[Docket No. 2008-0111]

Anthropomorphic Test Devices; ES-2re Side Impact Crash Test Dummy 50th Percentile Adult Male

ACTION: Final rule, response to petitions for reconsideration, technical amendment.

FIGURE 1: FULL BODY THORAX IMPACT TEST RESULTS FOR UPPER RIB DEFLECTION

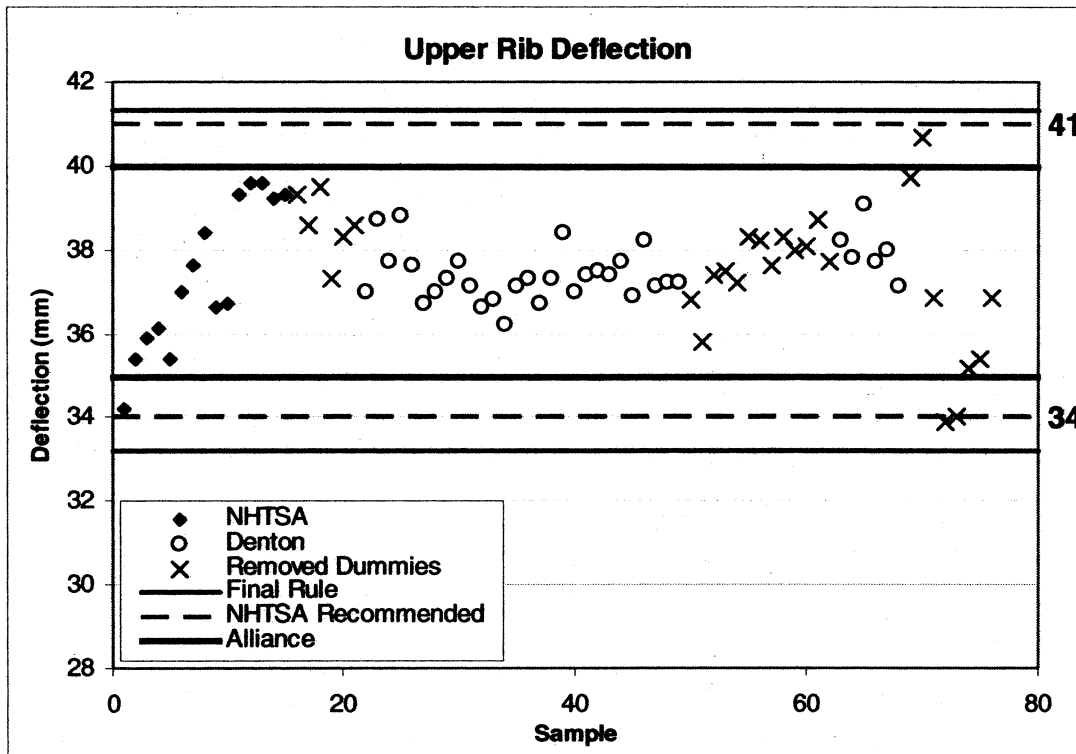
All of the data in the complete dataset (i.e., without any dummies removed) fit within the specified final rule corridor of 33.2–41.3 mm, as seen in Figure 1 below. The Alliance petitioned to narrow the corridor bounds to a range of 35–40 mm. The data set with the

indicated dummy responses removed (“revised data set”) has a mean deflection of 37.4 mm, a standard deviation of 1.11 mm and a CV of 2.96 percent. In that this CV is less than 3 percent, we could adopt corridor bounds that are expanded ±3 standard deviations from the mean,¹⁴ or a range

of 34.1–40.8 mm. When rounded to the next whole numbers away from the mean, this corridor becomes 34–41 mm, which is only slightly narrowed compared to the final rule. This corridor contains nearly all the NHTSA and DTESC data points, and is well-centered about the mean.

FIGURE 2: MIDDLE RIB DEFLECTION RESULTS FROM FULL-BODY THORAX IMPACT TESTS

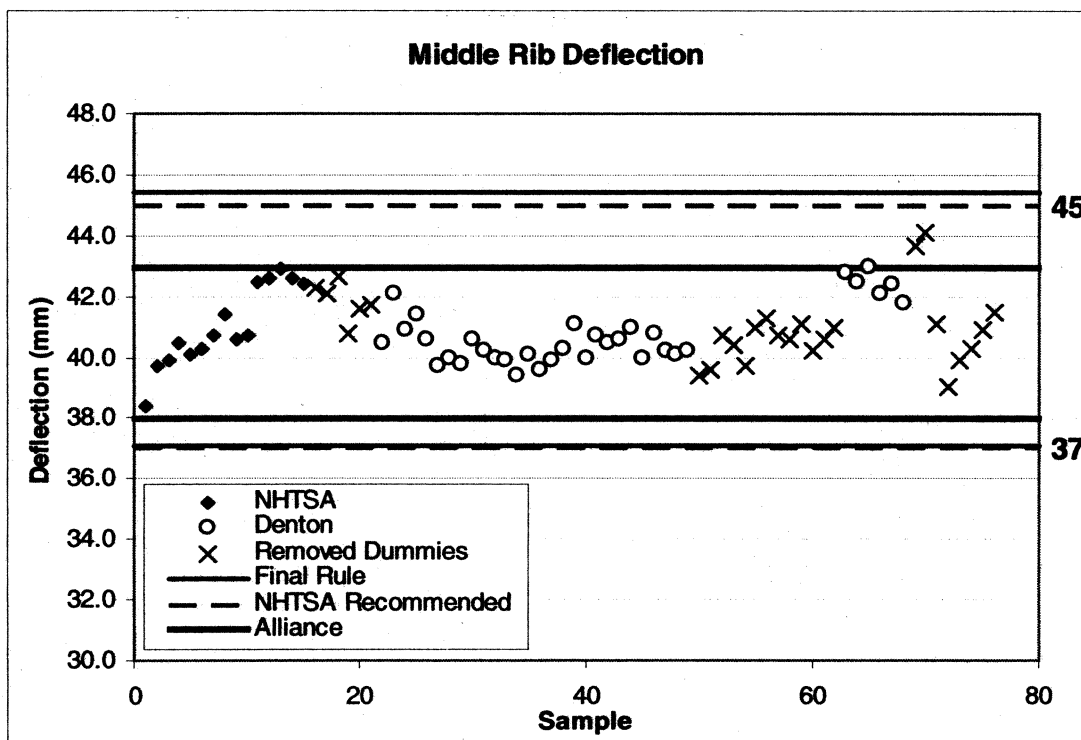
All data in the complete DTESC data set also fit within the corridors specified in the final rule for middle rib deflection, 37.1–45.4 mm (see Figure 2 below). However, the Alliance petitioned for narrowed corridor bounds

of 38–43 mm. Statistical analysis of the revised data set resulted in a mean response of 40.8 mm, a standard deviation of 1.09 mm and a CV of 2.67 percent. This CV allows for corridor bounds placed at ±3 standard deviations from the mean, or a range of 37.6–44.1 mm (37–45 mm when rounded away

FIGURE 3: LOWER RIB DEFLECTION RESULTS FROM FULL BODY THORAX IMPACTS

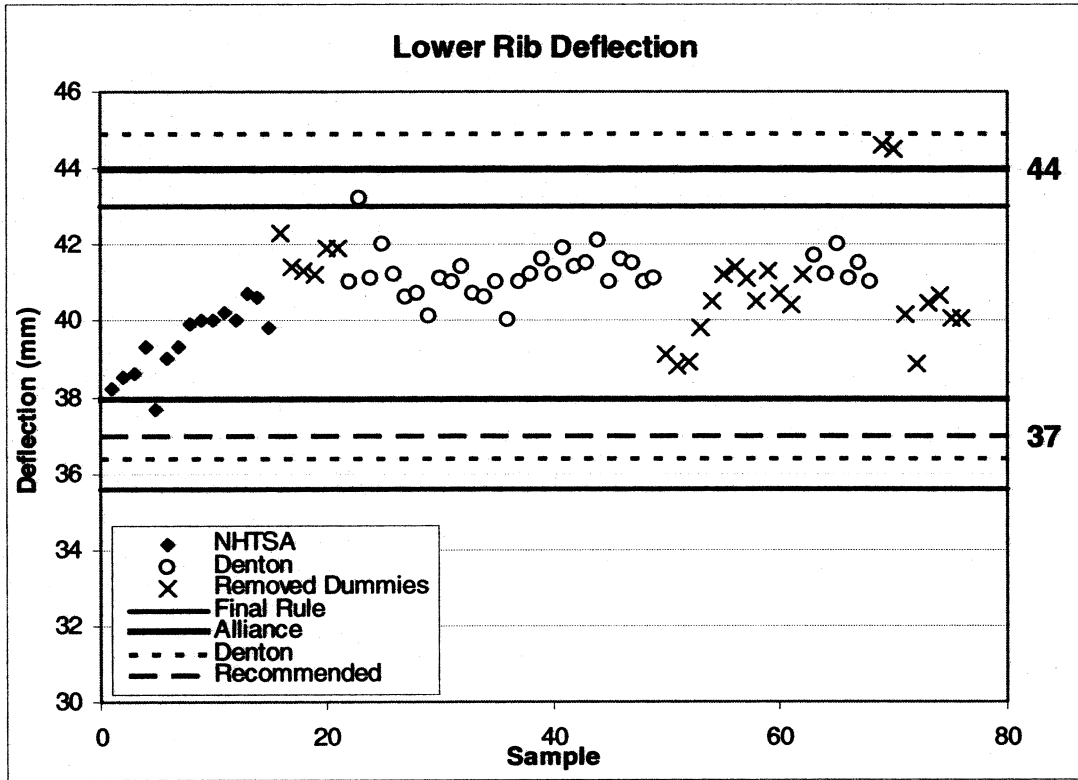
Denton and GM dummies in the DTEESC-compiled data set submitted in Denton's petition for reconsideration show deflections that are generally higher than those measured by NHTSA. The final rule specified a range of 35.6–43.0 mm, while the Alliance and Denton recommended corridors ranging from 38–44 mm and 36.4–44.9 mm,

respectively. Based on statistical analysis of the revised DTEESC data set, an adjustment of the corridor bounds to reflect these higher responses from a larger population of dummies is appropriate. The revised data set has a mean response of 40.7 mm, a standard deviation of 1.08 mm, and a CV of 2.66 percent. This CV allows for expansion of the bounds ± 3 standard deviations

from the mean, producing a range of 37.5–43.9 mm, or 37–44 mm when rounded away from the mean. This corridor is slightly smaller than and shifted upward from the final rule corridor, but wider than the corridor for which the Alliance petitioned. This corridor contains nearly all petitioner-submitted data as well as all NHTSA data (Figure 3).

FIGURE 4: TEST RESULTS FOR THE “PEAK IMPACTOR FORCE AFTER 6 MS” MEASUREMENT AS COLLECTED BY NHTSA, DENTON, GM AND FTSS

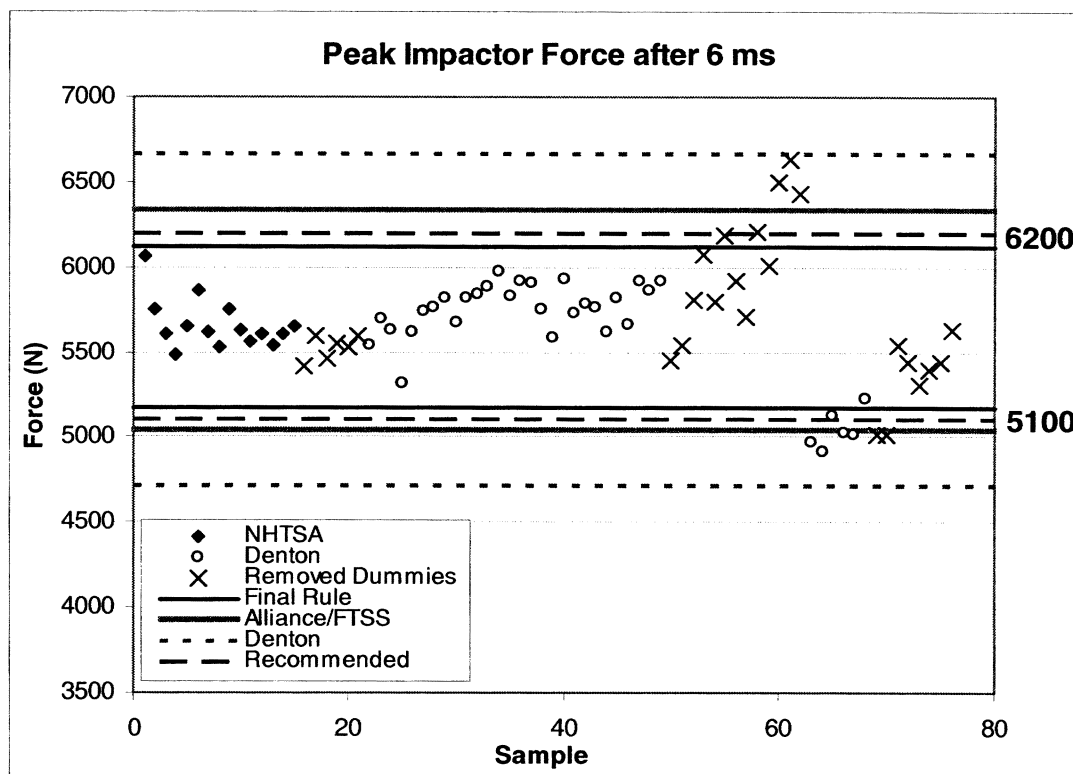
The additional peak impactor force data compiled by the SAE DTESC and submitted by Denton provide additional points with which to form statistically-based corridors. In its petition, the Alliance used this data set to propose a corridor of 5045–6344 N, while Denton recommended a range of 4720–6669 N,

as shown in Figure 4. FTSS recommended a performance corridor of 5039–6159 N for this measure. (The FTSS corridor is close to the Alliance recommendation, therefore to avoid clutter in Figure 4, it is shown to correspond to the Alliance corridor.) The mean response derived from the revised data set was 5643 N, with a SD

of 268 N and a CV of 4.76 percent. This CV allows for setting the corridor limits at ± 2 standard deviations from the mean, at 5107–6180 N. Rounded away from the mean, the lower and upper corridor bounds of the recommended corridor are 5100 N and 6200 N, respectively, a range very close to that which was petitioned by FTSS.

Figure U2-A
NECK/LUMBAR SPINE/HEADFORM ATTACHED TO PENDULUM

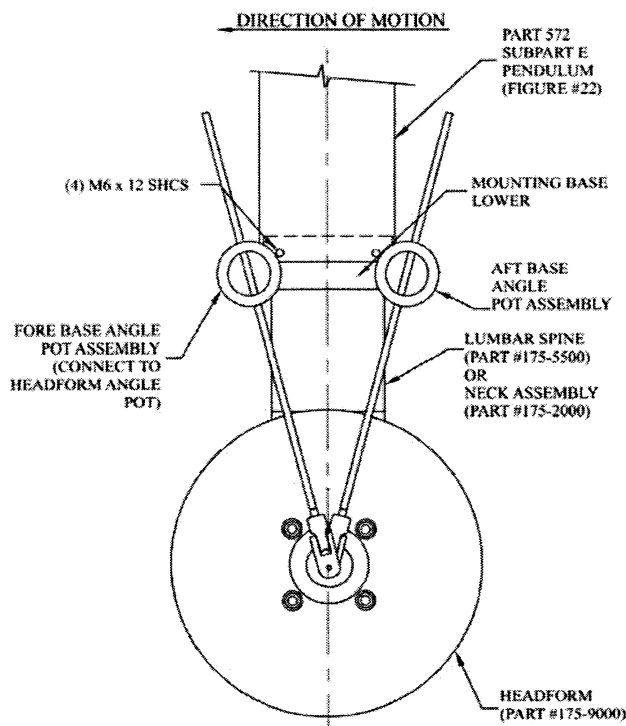
11. The agency has found an error in Figure U2-A, which specifies the pendulum for neck/lumbar spine qualification tests to be the "Part 572 Subpart E Pendulum (Figure #15)". The description and figure number do not refer to the same pendulum. This document makes a technical amendment by correcting the reference to read, "Part 572 Subpart E Pendulum (Figure #22)".

■ 8. Figure U2-A in “APPENDIX A TO SUBPART U OF PART 572—FIGURES” is revised to read as follows:
